AEMO 2024 draft ISP
mc² Energy submission
re: Section 6 Storage and gas to firm renewables

Figure 19 Storage installed capacity and energy storage capacity, NEM (2024-25 to 2049-50, Step Change)

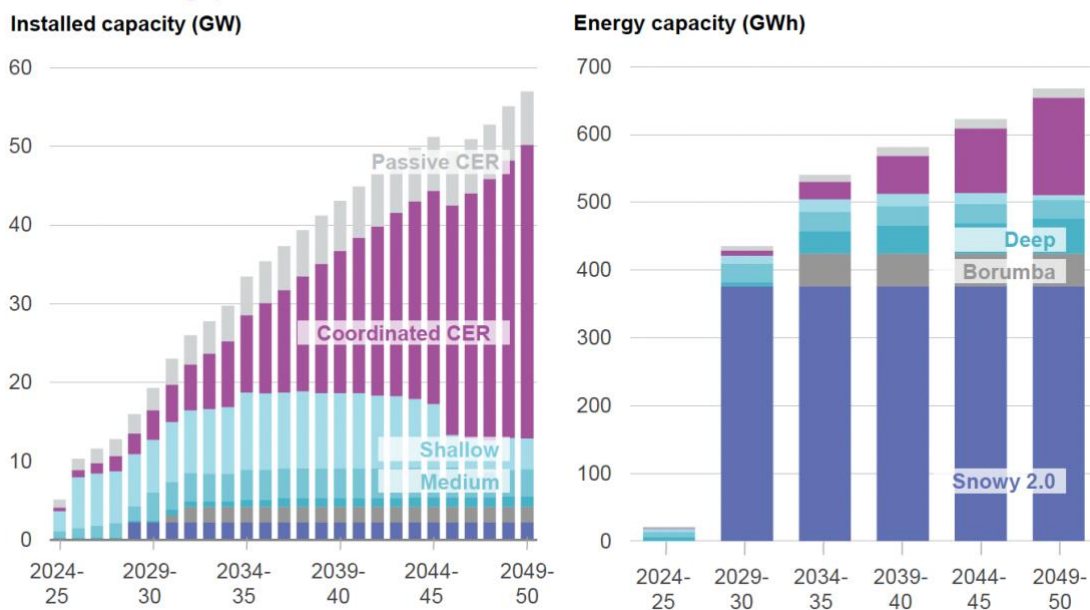
Section 6 of the draft 2024 ISP makes a number of assertions that require examination to establish their veracity. Chief among these claims is that Snowy 2.0 will provide 376 GWh of long duration storage. The implication from Figure 19 is that upon completion of Snowy 2.0 presumably in 2029, there is ample long duration storage in place to be able to close all NEM (NSW) coal fired generators (Figure 1) with system security. Here, we examine the veracity of the Snowy 2.0, 376 GWh storage (AEMO 2024 ISP) claim and the implications for system security if the accelerated coal generator closure timetable eventuates.

Does Snowy 2.0 have 376 GWh of long duration storage?

The simple answer is no, when taken in conjunction with another claim by Snowy Hydro that Snowy 2.0 will have no net water loss. If Snowy 2.0 does not have 376 GWh of energy storage then how much useable storage does it have? About 40 GWh (see attached schematic diagram).

It is impossible to drain Tantangara's theoretical maximum active storage (240 GL) into Talbingo's active storage¹ (155 GL) without overflow to Jounama pondage and water loss downstream from Snowy 2.0.

The claimed 376 GWh of energy storage capacity (AEMO 2024 ISP) for Snowy 2.0 would require at least 203 GL of water to flow from Tantangara to Talbingo, which also exceeds the active storage of Talbingo (155 GL), also causing overflow.

Using average active water storage in Tantangara and Talbingo, in a closed system² (not affecting river flows) a realistic operational energy storage capacity for Snowy 2.0 is around 40 GWh (Tantangara 22^{3,4} GL and 680m head).

Figure 1 Coal capacity, NEM (GW, 2009-10 to 2049-50)

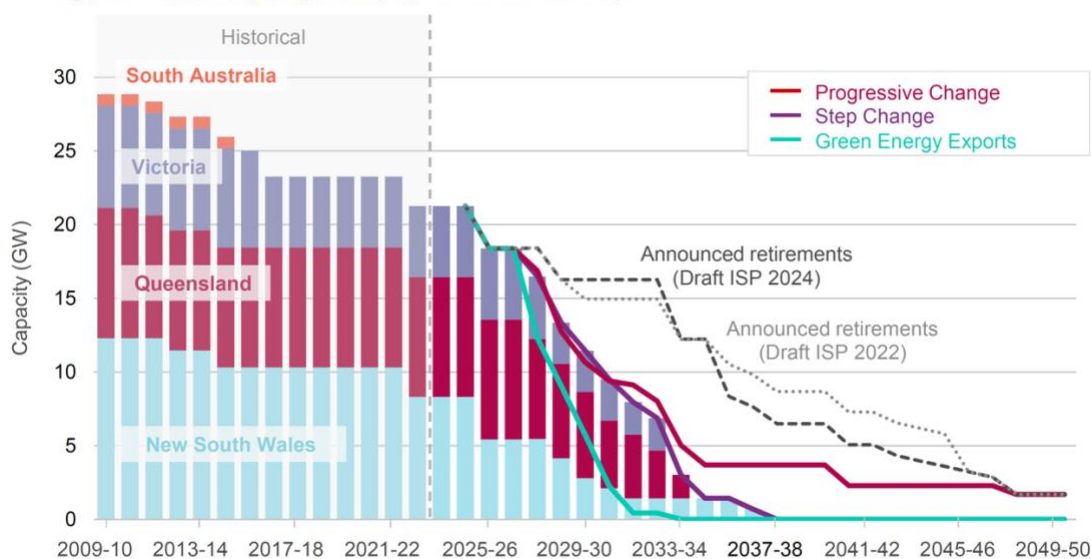
The timeline for closure of the remaining coal generators is now about 2035 (Figure 1 AEMO draft 2024 ISP) under the most likely Step Change scenario. This timeline is driven by the uptake of renewables, displacing relatively inflexible coal generators with a poor ramp rate, causing coal generators to run uneconomically. There is a timeline mismatch between the coal generator closures and the building of sufficient energy storage GWh to achieve genuine NEM competition = low consumer prices and guarantee energy security.
